**Fermi National Accelerator Laboratory
Batavia, IL 60510**

**LARGE HADRON COLLIDER
MAGNET ASSEMBLY TRAVELER**

**Reference Drawing(s)
Cold Mass Coil Insulation Assembly
MC-369582**

X 8.2 Install Quench Protector Heaters (MD-369619) onto the individual Coils. The Heater Leads extend out the Lead End.

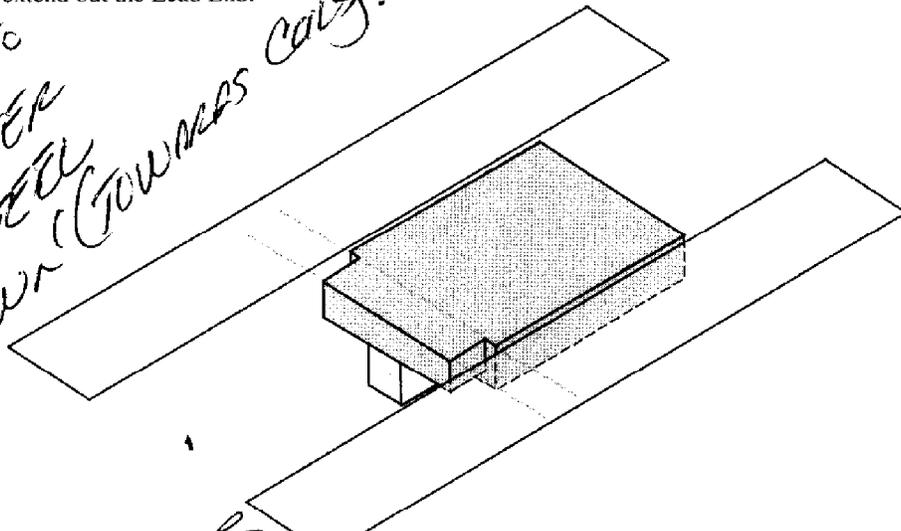
*TRR →
ADD TO STEP 10
INSTALL HEATER
STAINLESS STEEL
SIDE DOWN (TOWARDS COIL)*

*TRR
CHECK ALL STEPS TO
READ FOR CREW CALL
10 "VERIFYS" IN
OF DRAWING*

8.4 Install Pole Ground Wrap 1 (MC-369623). See Coil Insulation Assembly (MC-369582).

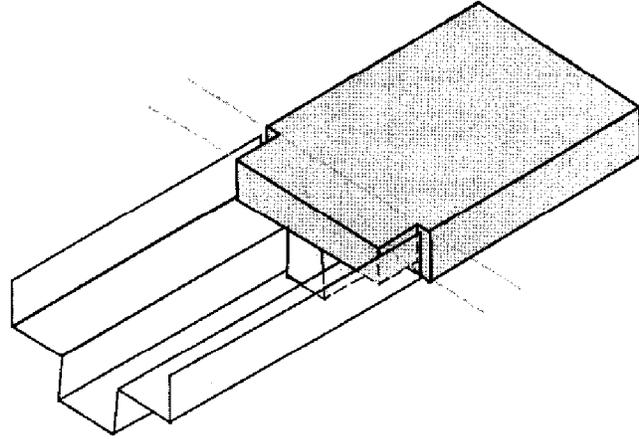
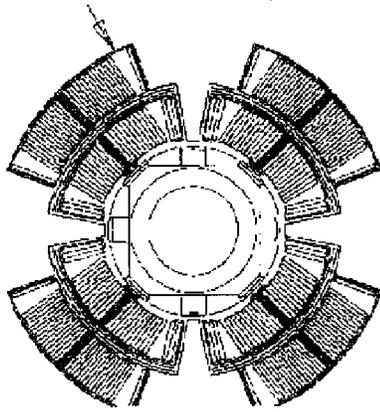
*FOR
CHANGE FOR CREW CHIEF
TO VERIFY & INSTALLATION*

X 8.10 Install Pole Ground Wrap 2 (MC-369624) to extend to back of Saddles. See Coil Insulation Assembly.

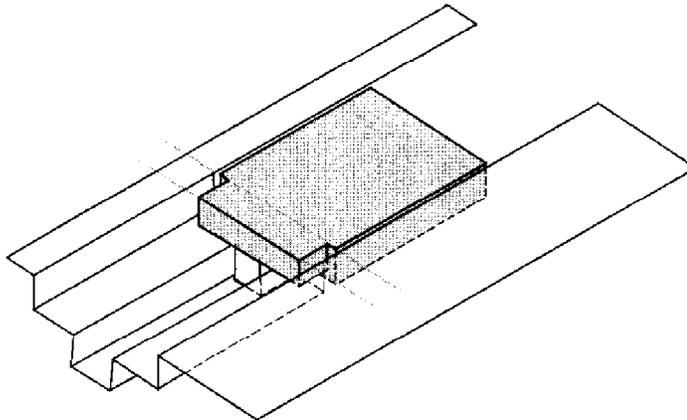
*TRP
CHANGES HAVE BEEN
MADE TO VERIFY
INSTALLATION*

X 8.12 Install Lead End Outer Coil Heater Strip Filler (MC-369632). See Coil Insulation Assembly (MC-369582).

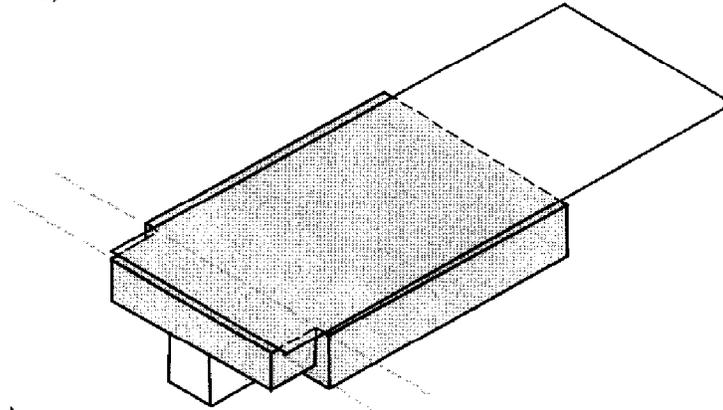
*TRR
CHANGE PER CREW CHIEF
TO VERIFY INSULATION*

X 8.14 Install Return End Outer Coil Heater Strip Filler (MC-369632). See Coil Insulation Assembly (MC-369582).

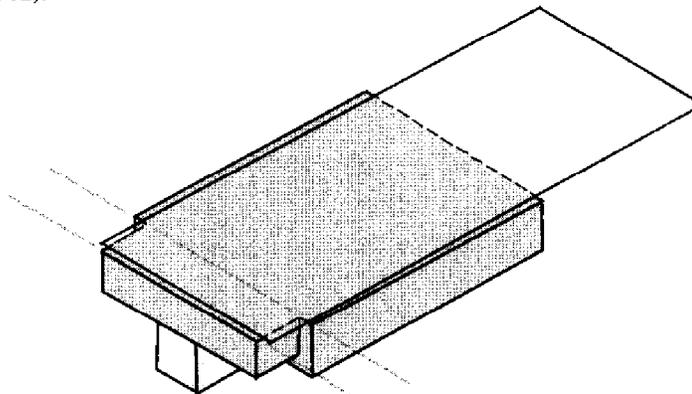
THE CHANGES FOR COIL INSULATION TO "WORKING" INSTALLATION

X 8.16 Install Pole Ground Wrap 3 (MC-369625). See Coil Insulation Assembly.

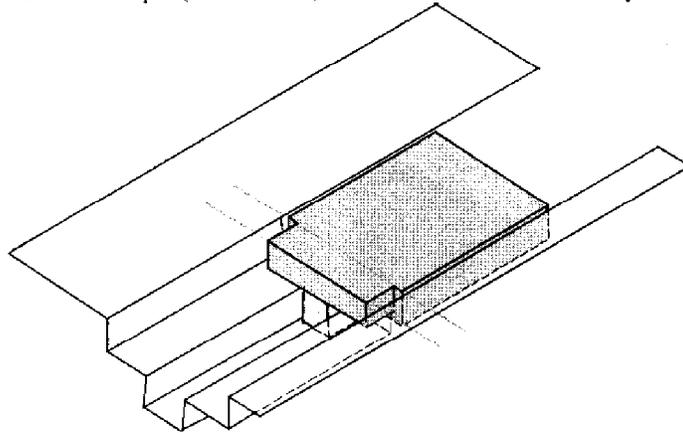
*7/1/01
CHANGE FOR CREW CHIEF
TO VERIFY & INSTALL*
